Re: Troutbeck Farms
Troutbeck Farm Developers LLC
Willistown Township, Chester County
Preliminary Subdivision and Land Development Approval

RE: Troutbeck Farms Subdivision – Monument Road, Friarsheel Lane, and Forest Lane Preliminary Subdivision and Land Development Plan Review

Site Plan Detail, Sheet 2 - Preliminary Subdivision - Troutbeck Farms

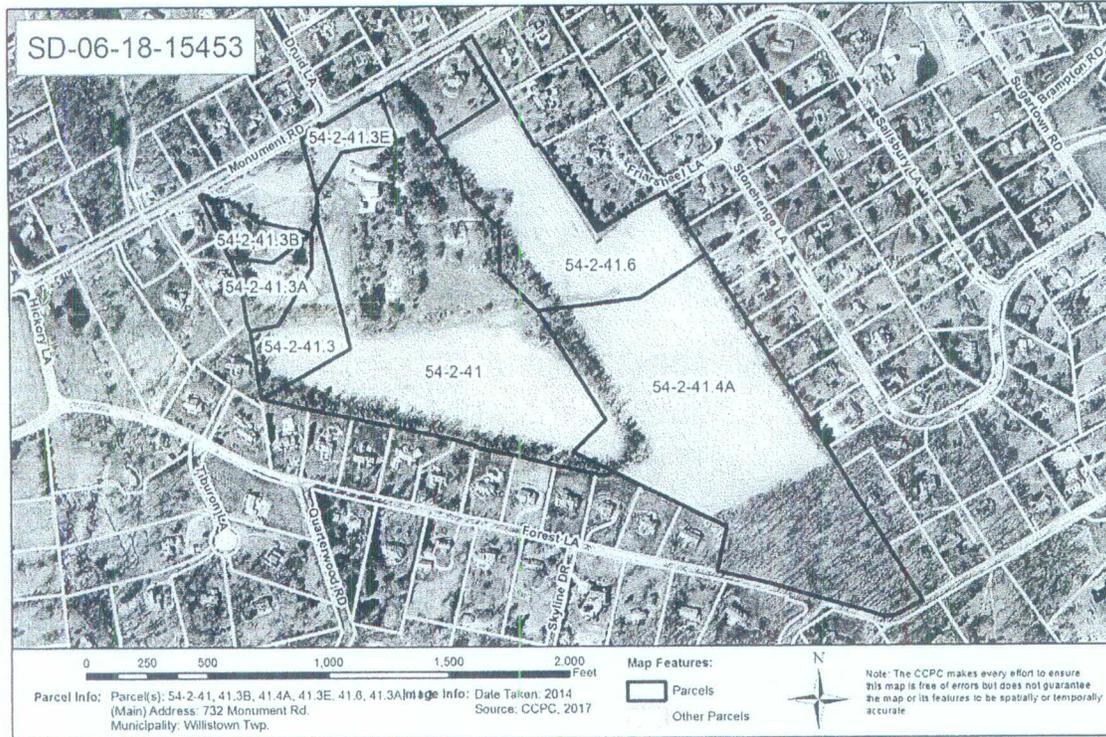
3. The 2011 Township Historic Resource Atlas identifies that the project site contains three Class II Historic Resources. The applicant should identify the location of the existing historic resources on the site plan, and specify the level of preservation and intended use of these existing historic resources. The Township should reserve granting final plan approval until the proposal has been reviewed by the Township's Historical Commission. The County Planning Commission
